Project	IEEE 802.16 Broadband Wireless Access Working Group < http://ieee802.org/16 >	
Title	Comments on AWD Idle Mode	
Date Submitted	2009-07-06	
Source(s)	Yih-Guang Jan, Yang-Han Lee, Hsien-Wei Tseng, Ming-Hsueh Chuang, Jheng-Yao Lin Tamkang University (TKU)	yihjan@yahoo.com
	Youn-Tai Lee, Chun-Yen Hsu Institute for Information Industry (III)	lyt@nmi.iii.org.tw
	Shiann-Tsong Sheu National Central University (NCU)	stsheu@ce.ncu.edu.tw
	Whai-En Chen National Ilan University (NIU)	wechen@niu.edu.tw
Re:	802.16m amendment working document "Comments on AWD 15.2.17 Idle Mode"	
Abstract	Comments on AWD Idle Mode	
Purpose	To be discussed and adopted by TGM for the 802.16m AWD.	
Notice	<i>This document does not represent the agreed views of the IEEE 802.16 Working Group or any of its subgroups. It represents only the views of the participants listed in the "Source(s)" field above. It is offered as a basis for discussion. It is not binding on the contributor(s), who reserve(s) the right to add, amend or withdraw material contained herein.</i>

Comments on AWD Idle Mode

Figure 420–Procedures during Type 2 ABS initiates idle mode entry

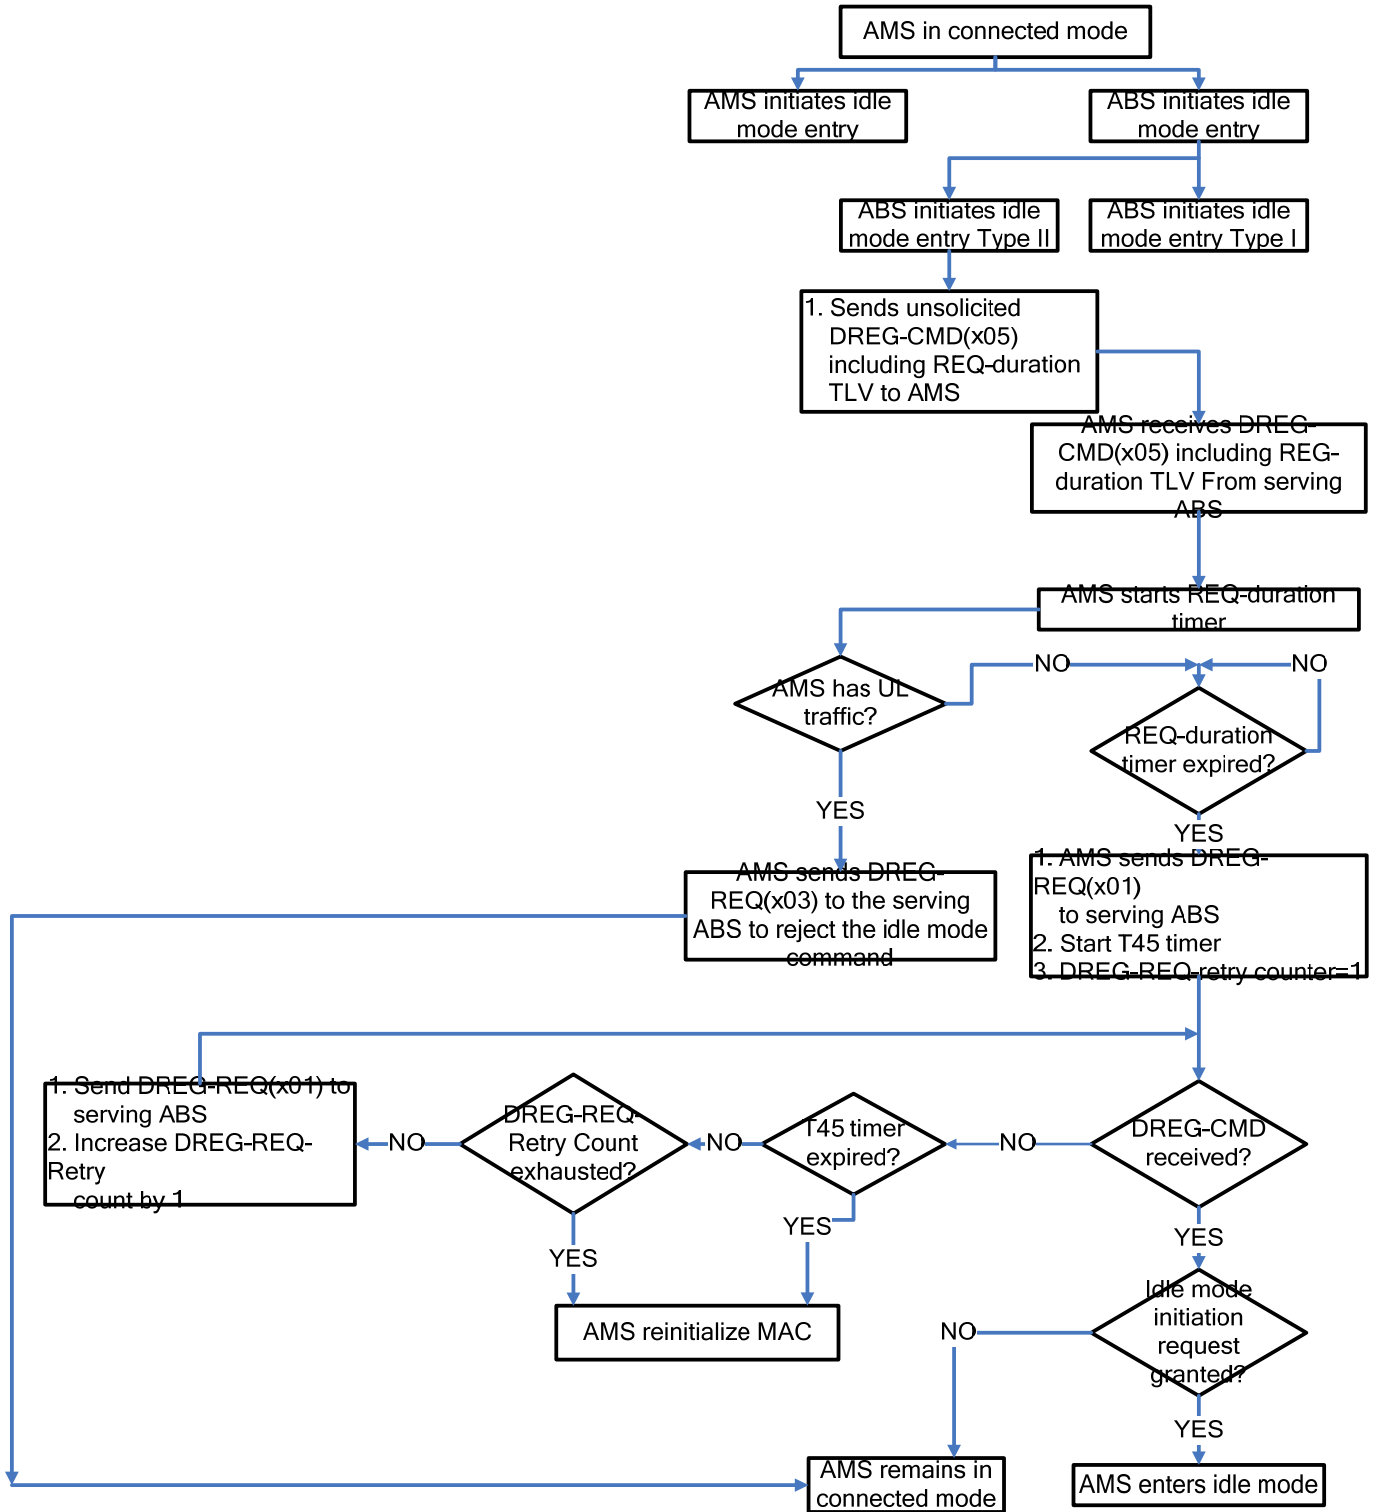
This contribution provides the corrected AWD text proposal to ABS initiates. In Figure 420, it has some errors in the functional blocks and needs correction.

[In IEEE 80216m-08_0010r2, Section 15.2.17.1.2, replace the original Figure 420 by the following modified figure.]
